SUBJECT: SAFETY RECALL OF 2009 - 2011 MCI D SERIES COACHES

Ref.: **MCI Service Bulletin 388B**
NHTSA # 14V-329
(Prior NHTSA # 12V-250)
Transport Canada # 2014-236
(Prior Transport Canada # 2012-173)

Service Bulletin No. 388B

MODEL D Series Coaches	TYPE Field Change Program	SECTION/GROUP 7 – Electrical	DATE July 14, 2014
SUBJECT INTERIOR LED LIGHTS			
CONDITIONS

Figure 2.

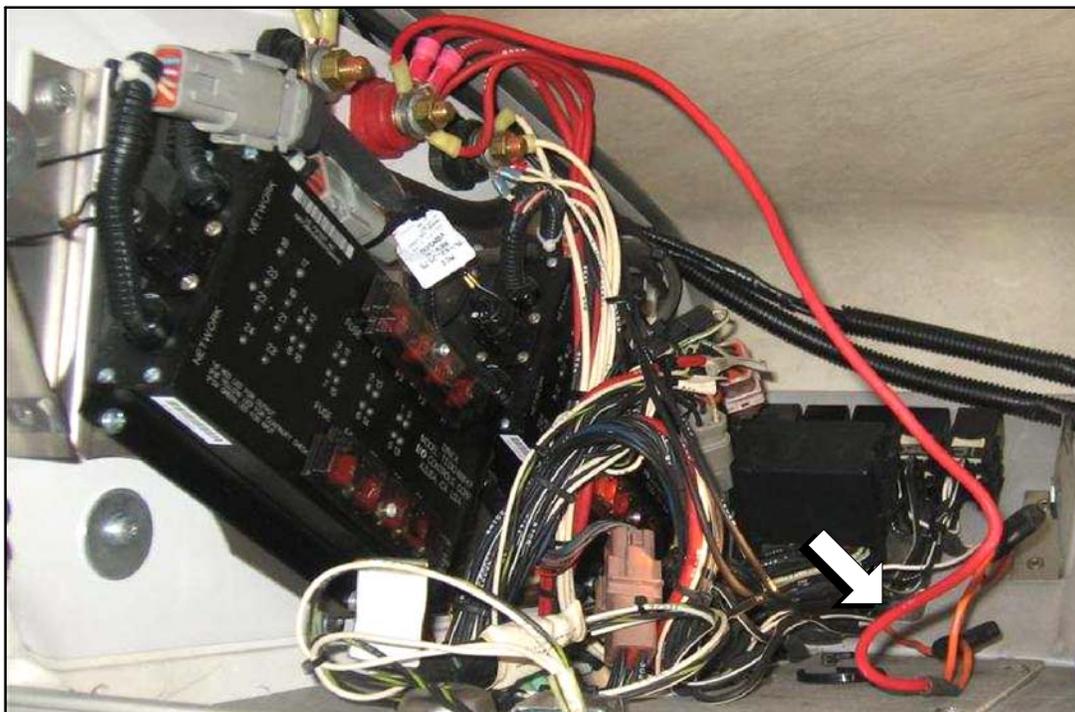
- 6. Locate the red and orange wires installed in the procedure steps of FCP388 (refer to Figure 2).

Figure 3.

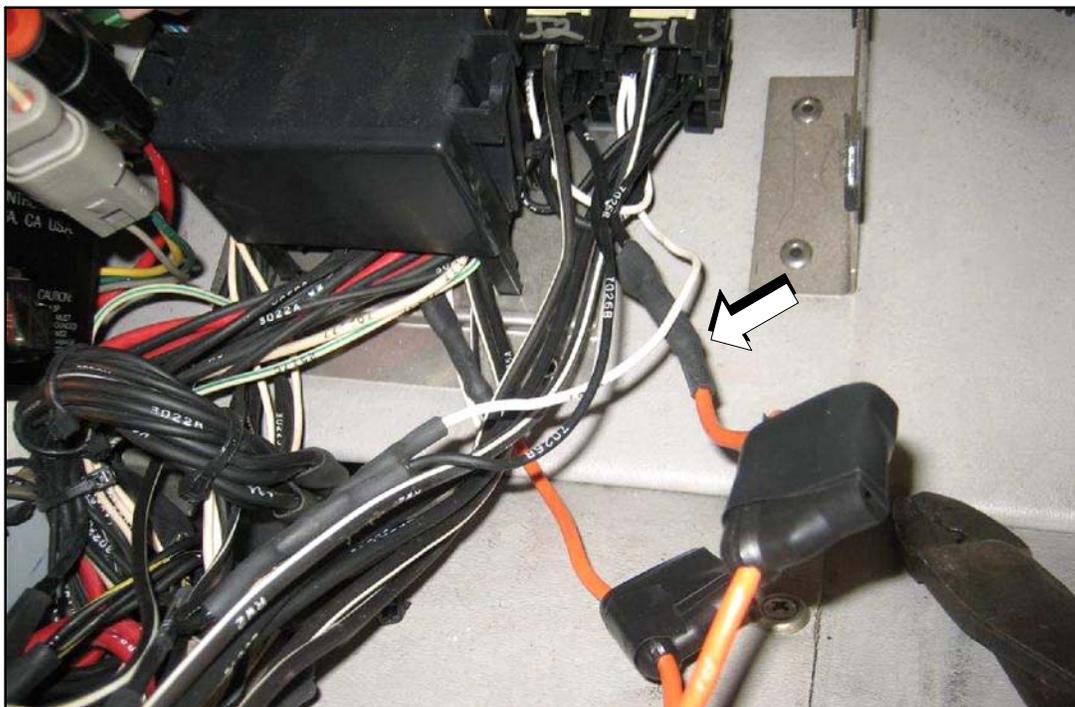
- 7. Locate the fuse holders (refer to Figure 3). Using wire cutters, cut the wires at the wire splice.

Figure 4.

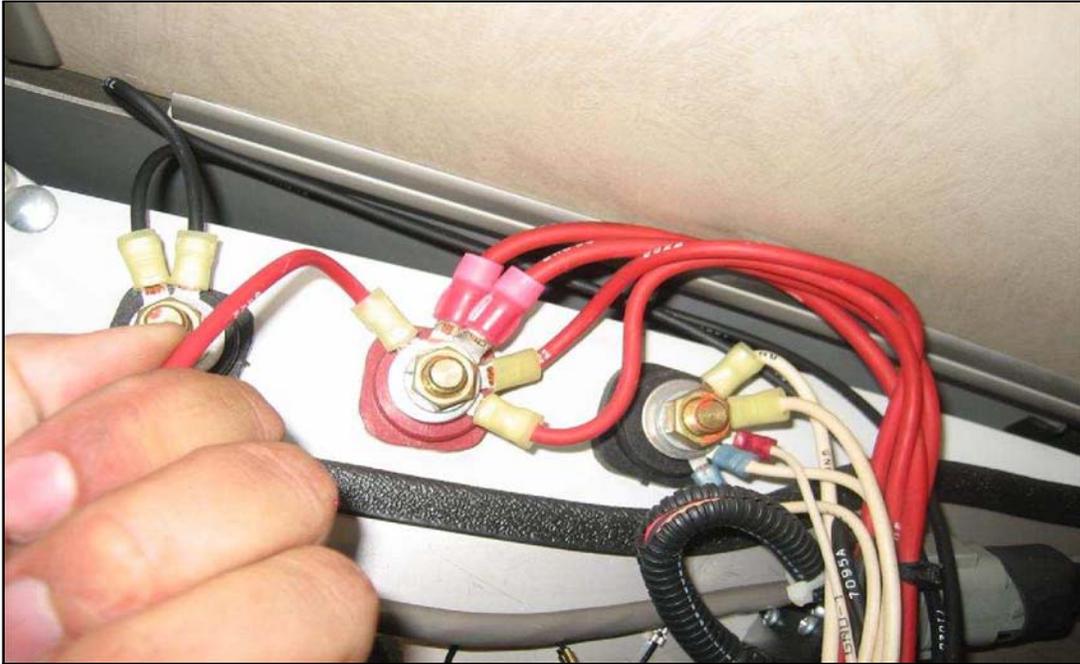
8. Trace the routing of the red wire cut at the wire splice to the 24 VDC red stud block. Remove and retain the nut. Remove and discard the red wire. Return the nut to the stud block.

Figure 5.

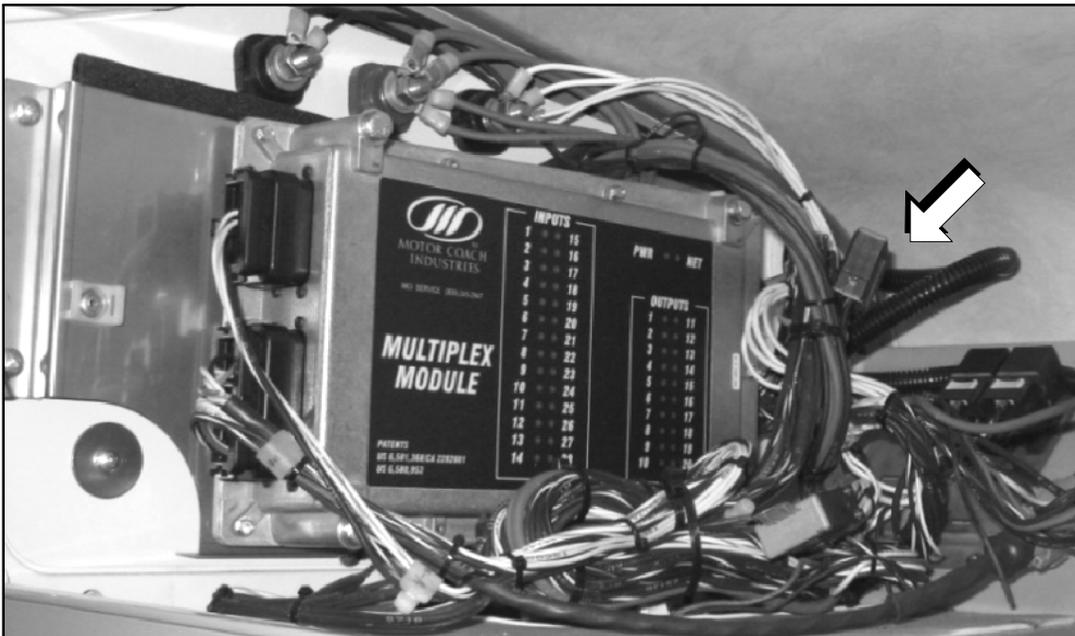
9. Locate connector S102 (refer to Figures 5 and 6).

10. Locate circuits A1, RA1 and LA1C in connector S102 cavities E, D and F. Using wire cutters, cut the wires 0.50 inch from the connector and splice them together using heat shrink, p/n 07-08-4684 (see Figure 7).

11. Locate circuits W1, RW1 and LW1C in connector S102 cavities L, K and M. Using wire cutters, cut the wires 0.50 inch from the connector and splice together using heat shrink, p/n 07-08-4684. (refer to Figure 7).

Figure 7.

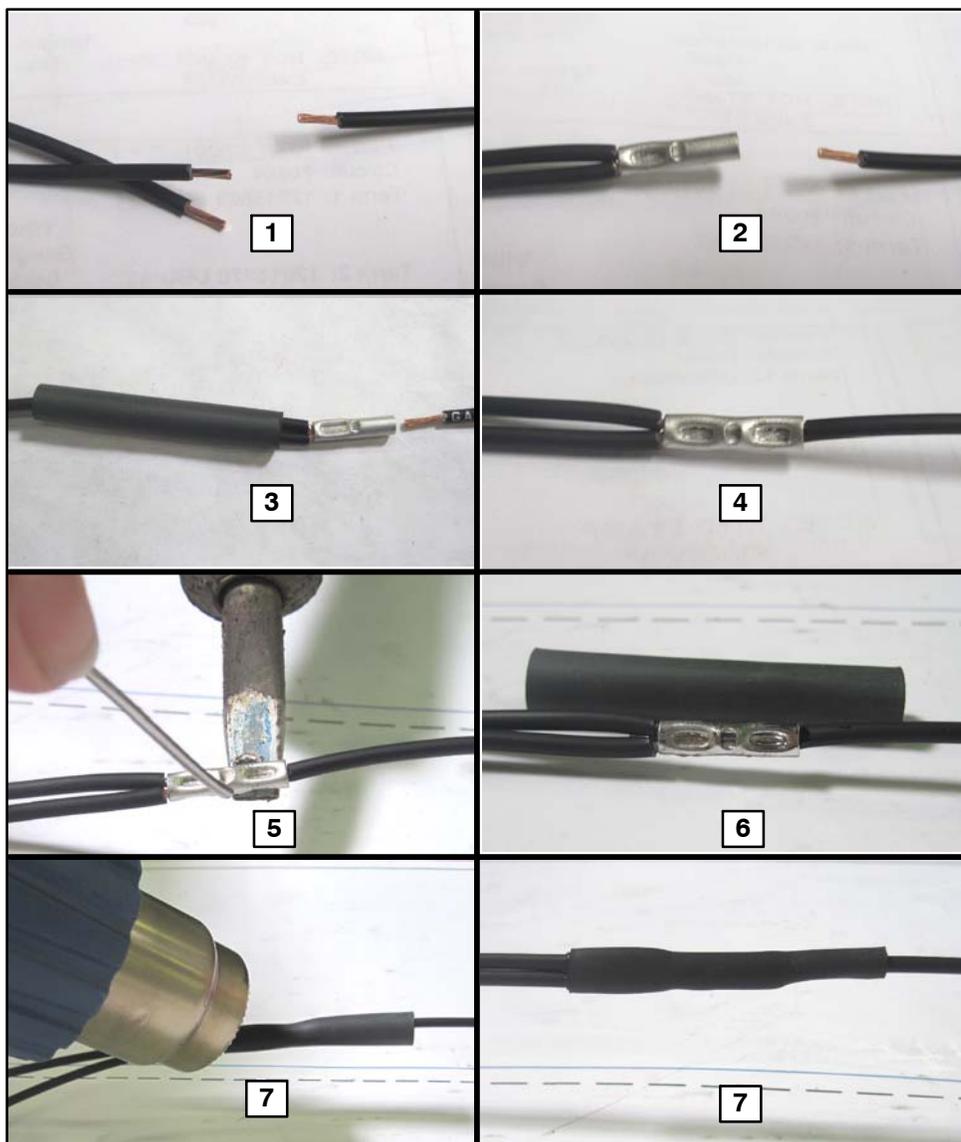
12. Using a small removal tool, remove circuit LW2A from connector S102 cavity J and splice with circuit LW2A from the Interior Light Relay Kit, p/n 07-08-4682B using heat shrink, p/n 07-08-4685 (refer to Figure 7).

13. Remove circuit RW2 from connector S102 cavity G and splice with circuit RW2 from the Interior Light Relay Kit, p/n 07-08-4682B, using heat shrink p/n 07-08-4685 (refer to Figure 7).

14. Remove circuit LA3A from connector S102 cavity C and splice with circuit LA3A from the Interior Light Relay Kit, p/n 07-08-4682B, using heat shrink p/n 07-08-4685 (refer to Figure 7).

15. Remove circuit RA3A from connector S102 cavity A and splice with circuit RA3A from the Interior Light Relay Kit, p/n 07-08-4682B, using heat shrink p/n 07-08-4685 (refer to Figure 7).

16. Discard the connector S102.

Figure 9. Relay K location in curbside, parcel rack compartment #1.

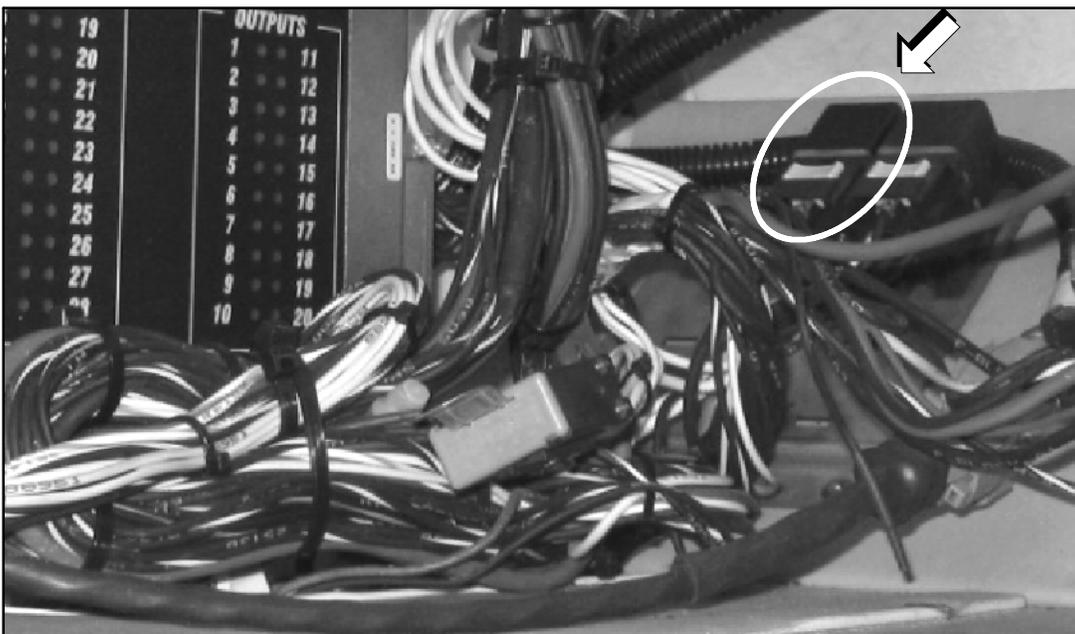
20. Locate Relay K (refer to Figure 9). Remove circuit 7029 from Relay K cavity 86 and splice with circuit 7029 from the Interior Light Relay Kit, p/n 07-08-4682B, using heatshrink, p/n 07-08-4684.
21. Remove circuit 70291 from Relay K cavity 85 and splice with circuit 70291 from relay kit (07-08-4682B) using 07-08-4684.
22. Discard Relay K and its base. Using wire cutters, cut and remove any other wire connected to the relay.

Figure 10. Fuse block in curbside, parcel rack compartment #1.

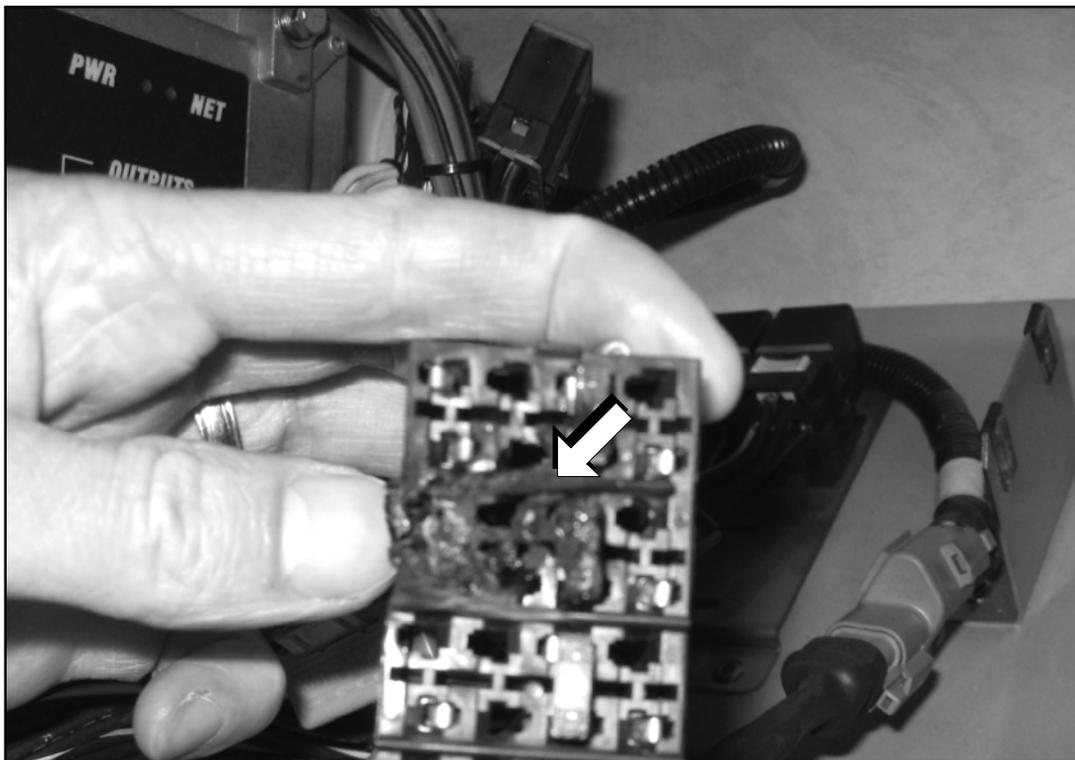
Upon visual inspection, if the fuse block exhibits signs of heat damage or melting, contact the MCI Fleet Support Technical Center at 1-800-241-2947 for further information and replacement parts.

23. Visually inspect the fuse block for heat damage or melting at locations A1 and A2 (refer to Figure 10).

Figure 11.

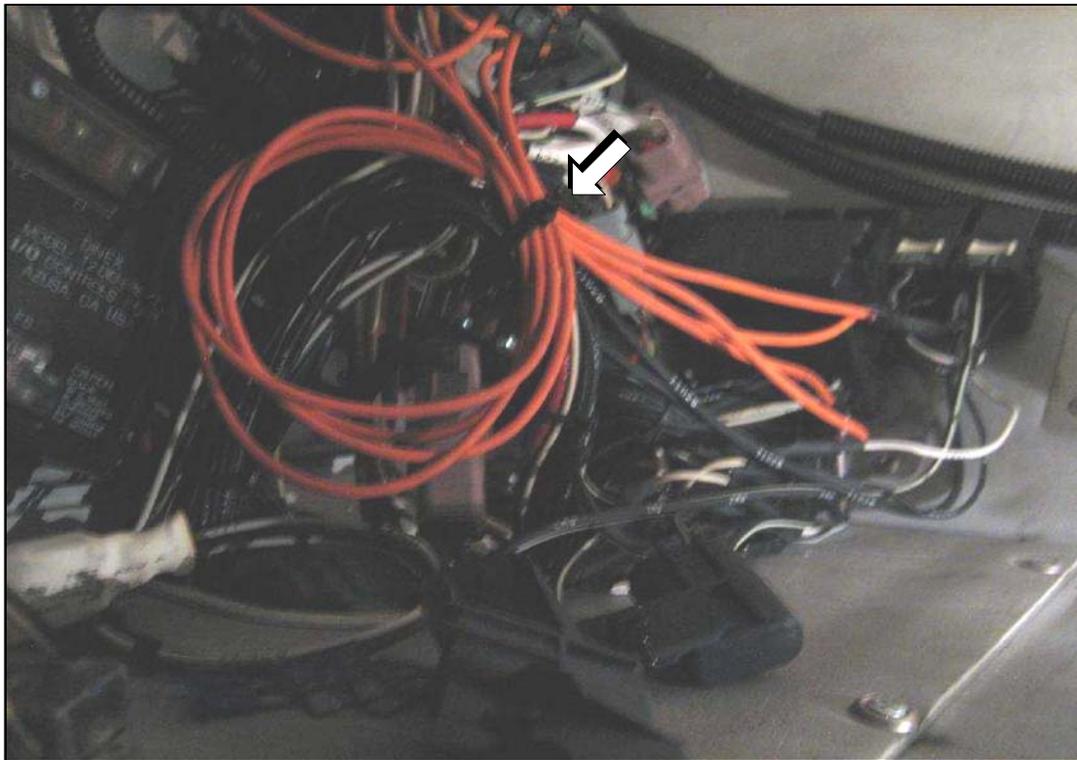
24. Using the screw, p/n19-1-640, secure Relays J1, J2, K1, K2 from the Interior Light Relay Kit to the bracket.
25. Secure circuit 8822 from the Interior Light Relay Kit to the 24V power stud.
26. Secure circuit 7095A from the Interior Light Relay Kit to the instating light stud.

27. Secure the harness installation using tytraps, p/n 19-11-258.

Figure 12. Decal legend location on junction box cover in curbside, parcel rack compartment #1.

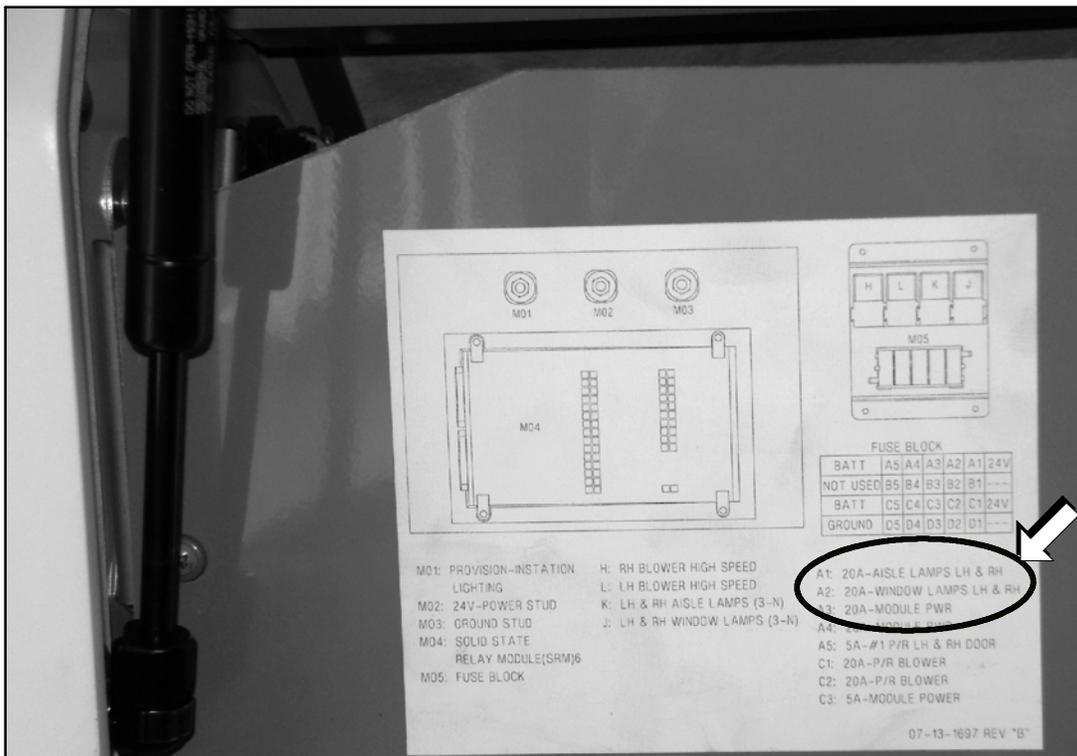
29. Using the decals, p/n 07-08-4682B, cover locations A1 and A2 on the Decal legend affixed to the junction box cover.
